Subject: LaSalle County Station Units 1 and 2
Supplement to Application for Amendment to Facility
Operating Licenses NPF-11 and NPF-18, Appendix A,
Technical Specifications
NRC Docket Nos. 50-373 and 50-374.

Reference (a): W.E. Morgan letter to USNRC dated October 10, 1990;
transmitting CECO's original request to remove
Technical Specification requirements for the HPCS CST
Suction Valve and adding containment isolation
requirements for the new RCIC line.

DESCRIPTION AND SAFETY ANALYSIS OF PROPOSED CHANGES TO APPENDIX A, TECHNICAL SPECIFICATIONS OF FACILITY OPERATING LICENSES NPF-11 AND NPF-18

Figure 1

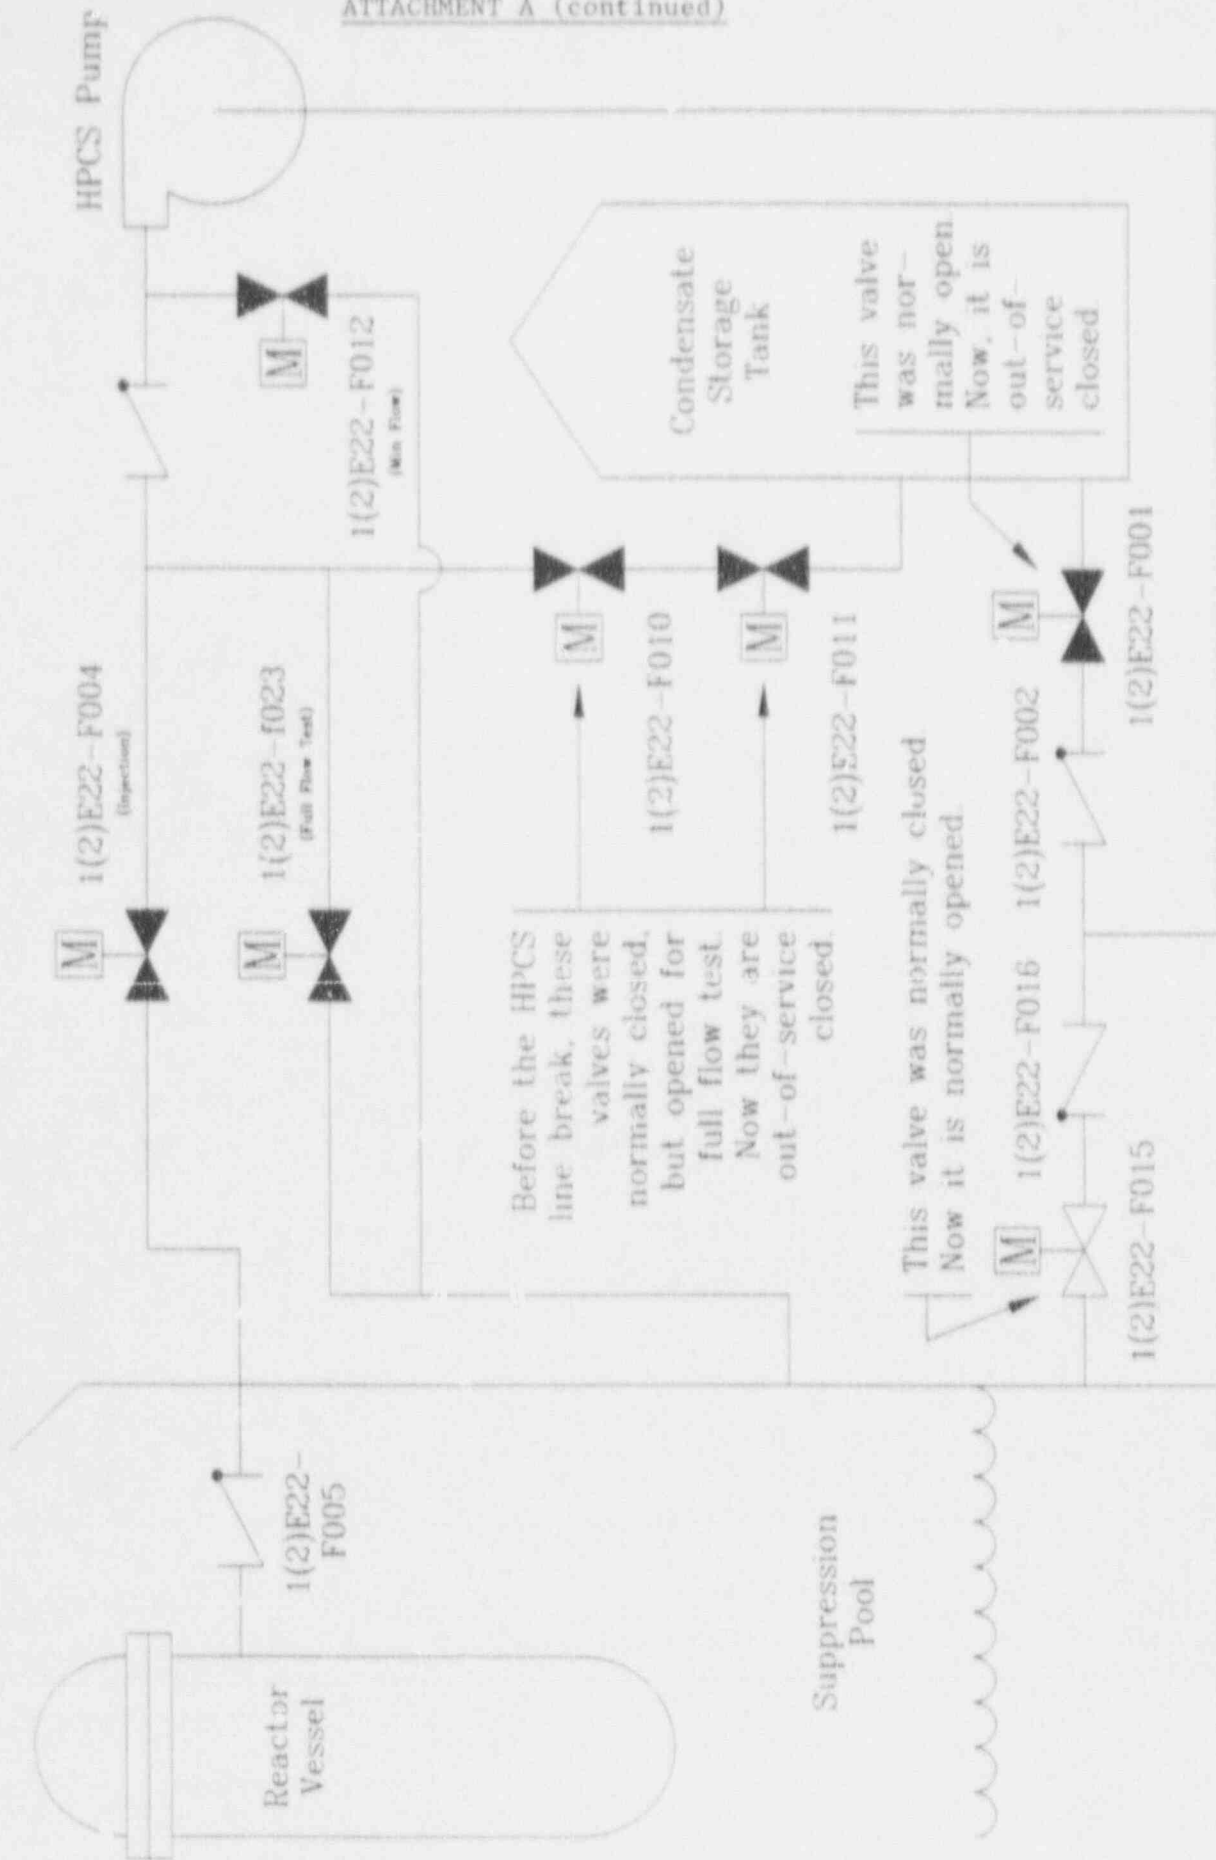
Since the ECCS pumps are required to take suction from the suppression pool to mitigate the consequences of a loss-of-coolant accident, the normal position for the ECCS pump suction valves is open. HPCS is a unique ECCS system at LaSalle Station in that it was originally designed to first, take suction from the CSI and second, take suction under prescribed conditions from the suppression pool. The new design for the HPCS system leaves the suppression pool suction valve open and makes the system configuration very close to that of the Low Pressure Core Spray (LPCS) system. The modifications will change the thermal overload bypass circuitry for the 1(2)E22-F015 valve to be bypassed continuously as opposed to being bypassed under accident conditions only. This change will make the thermal overload bypass circuitry configuration for the 1(2)E22-F015 valve consistent with the circuitry for the LPCS system suppression pool suction valve (1(2)E21-F001).

At the request of the NRC Staff, a simplified drawing of the modified HPCS system is attached with this evaluation (Figure 1).
